PRODUCT
SUPPORT
BULLETIN # 233

SUBJECT: 31-50-0425 MOTOR HOUSING \ LOCTITE OF FIELD & GEAR CASE SCREWS

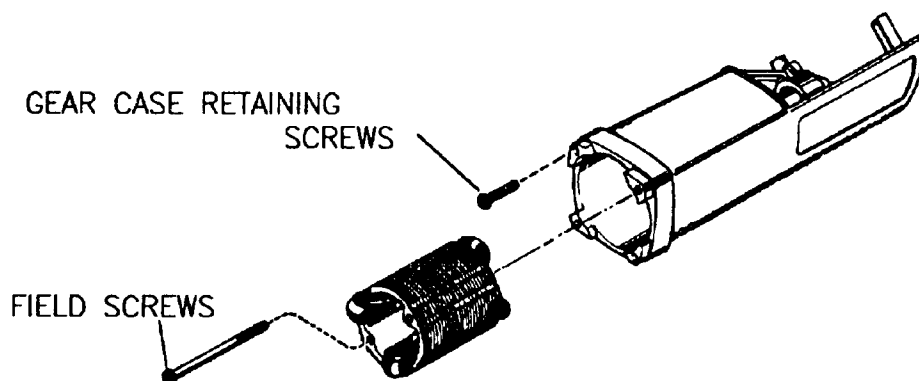
WHEN SERVICING ANY DIE GRINDER, RANDOM ORBIT SANDER, 4-1/2" & 5" ANGLE GRINDER, SHEAR OR NIBBLER:

APPLY A DROP OF TYPE 242 "BLUE" LOCTITE OR EQUIVALENT TO THE TWO (2) FIELD SCREWS (06-82-7375) AND THE FOUR (4) GEAR CASE RETAINING SCREWS, PROVIDING ADDITIONAL HOLDING FORCE.
